STATE OF CONNECTICUT
CONNECTICUT SITING COUNCIL

SBA TOWERS III/NEW CINGULAR
WIRELESS PCS, LLC APPLICATION FOR A
CERTIFICATE OF ENVIRONMENTAL
COMPATIBILITY AND PUBLIC NEED
FOR A TELECOMMUNICATIONS FACILITY
LOCATED AT WEWAKA BROOK ROAD
BRIDGEWATER, CONNECTICUT

DOCKET NO. 412

SBA TOWERS III (“SBA”) AND NEW CINGULAR WIRELESS PCS, LLC (“AT&T”)
RESPONSES TO TOWN OF BRIDGEWATER INTEROGATORIES

SR1860 Drive Test
 @ 175' AGL

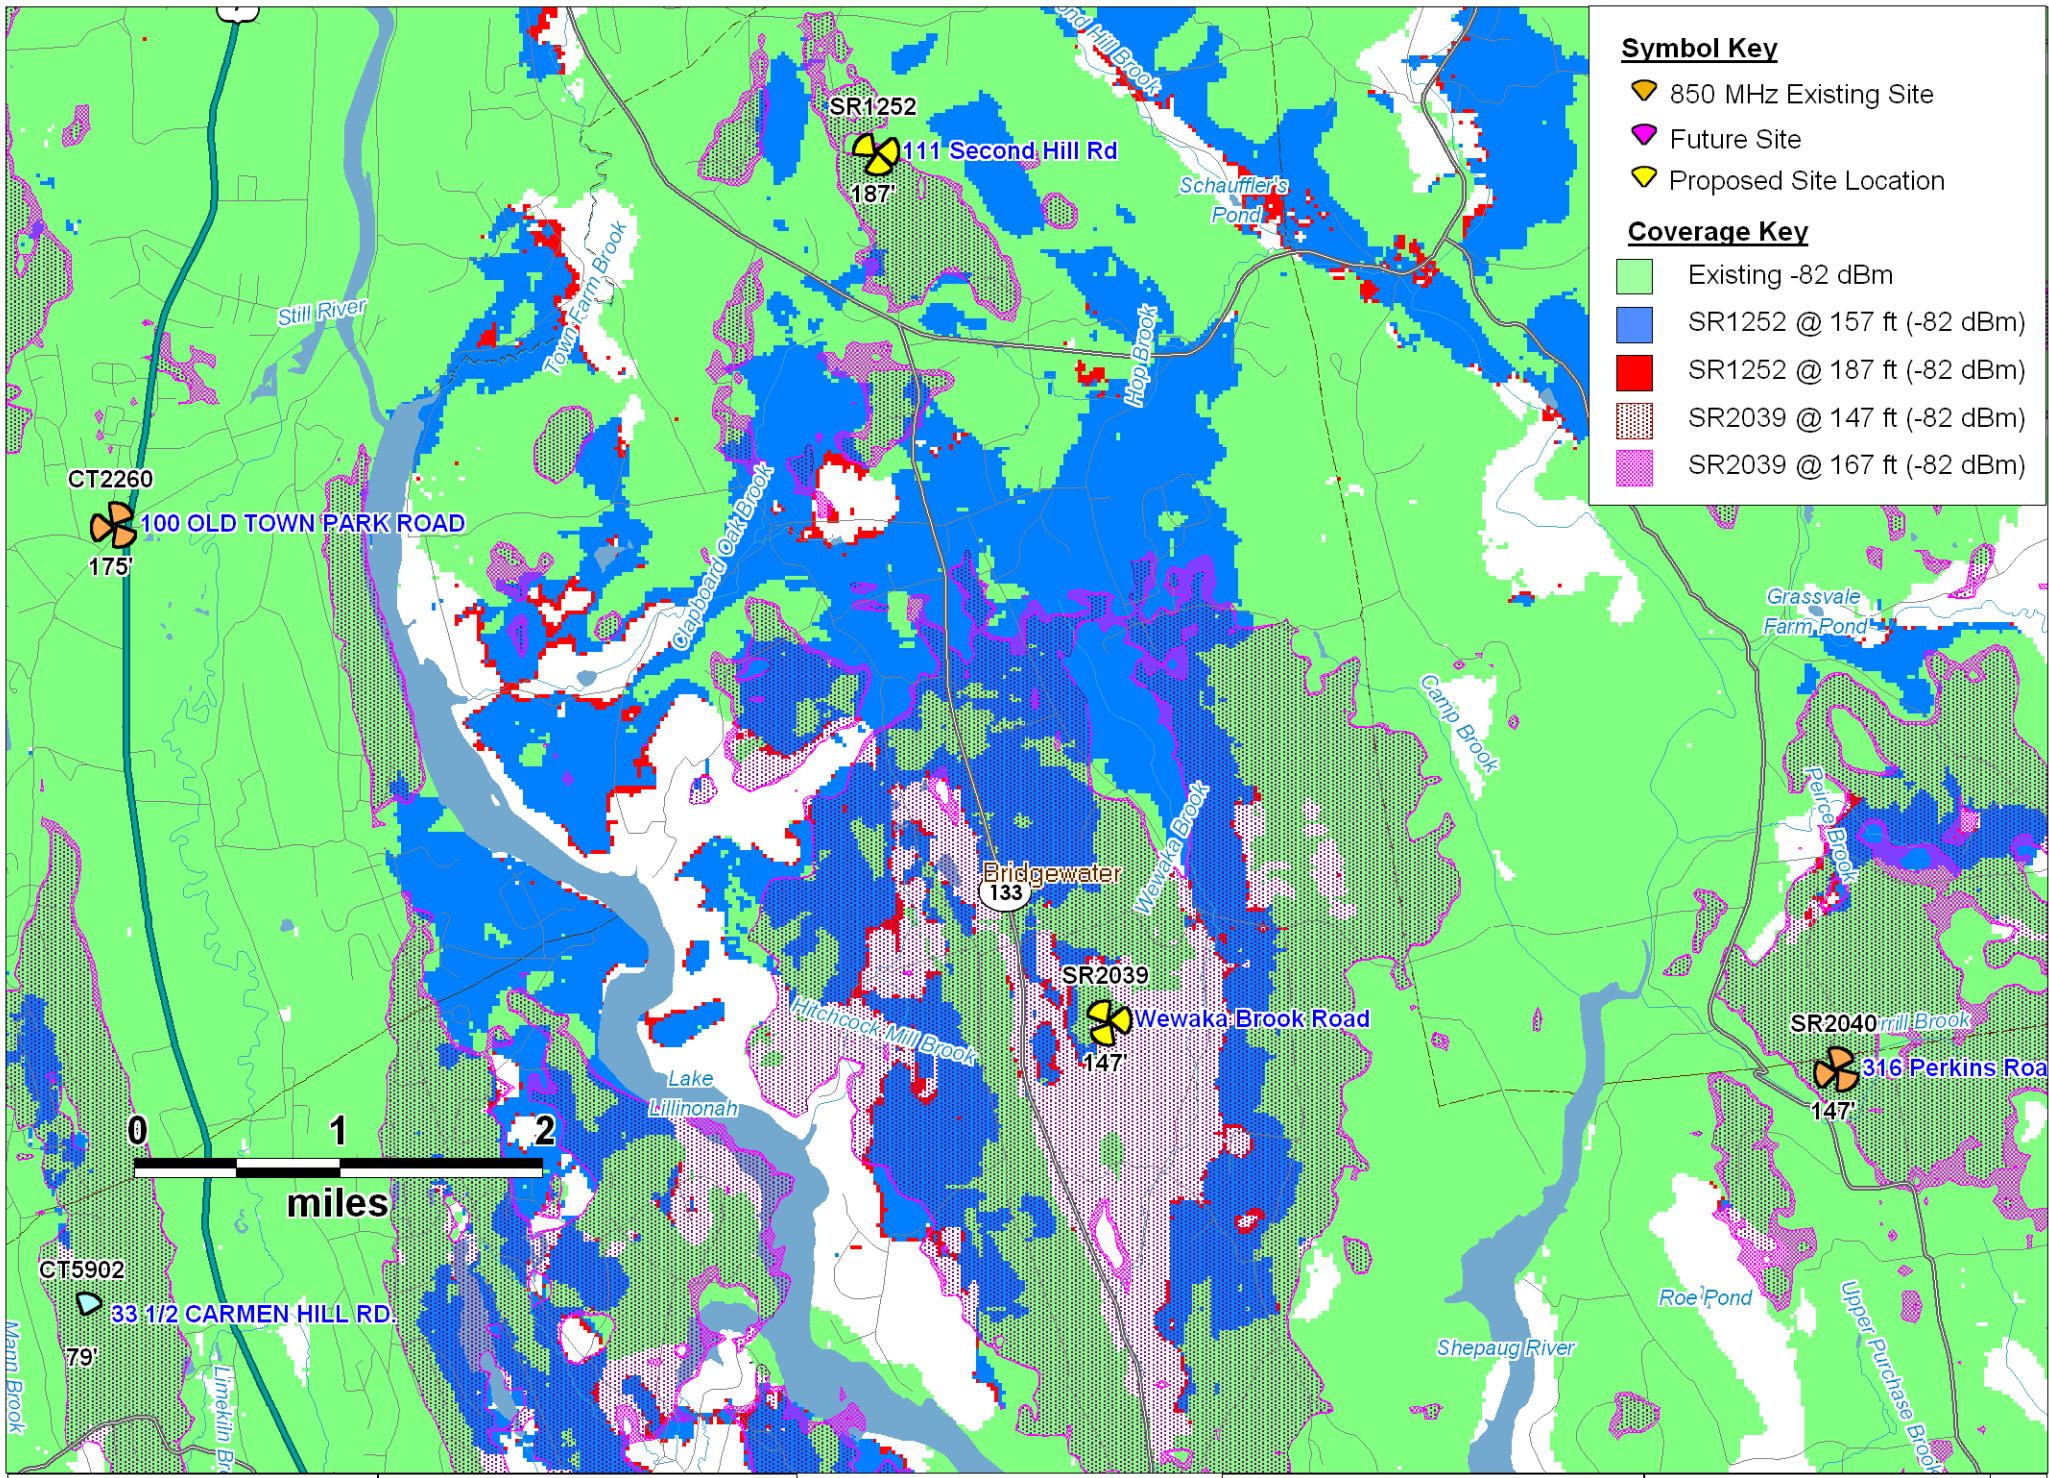
Q23. Please provide any data collected in drive tests or other field tests of the signal strength from the wireless tower at Dinglebrook Road in Newtown, CT?

Q42. Could the Dinglebrook facility be re-configured (e.g.: increased power, different antennas) to provide more coverage to the north into Bridgewater thereby allowing for the Wewaka Brook tower to be made shorter?

A23. No drive test or other field test data of the referenced site as constructed is yet available. However, included as Attachment 5 please find a drive test analysis which was conducted prior to the construction of the Dinglebrook facility using a crane raised to 175’ AGL (which is notably 25’ above the 150’ AGL height of the tower as constructed). This drive test data demonstrates that even at 175’ AGL the Dinglebrook facility cannot provide coverage beyond a small portion of southern Bridgewater which lies at a lower elevation relative to the rest of the Town and the area of need.

A42. No. Local terrain and topography, maps of which are included in the Application behind Tab 1, limit the extent to which service can be provided to the north. Included in Attachment 5 is a drive test analysis conducted prior to the construction of the Dinglebrook facility which used a crane at the site raised to 175' AGL (which is notably 25' above the 150' AGL height of the tower as constructed). This drive test data demonstrates that even at 175' AGL the Dinglebrook facility cannot provide coverage beyond a small portion of southern Bridgewater which lies at a lower elevation relative to the rest of the Town and the area of need.
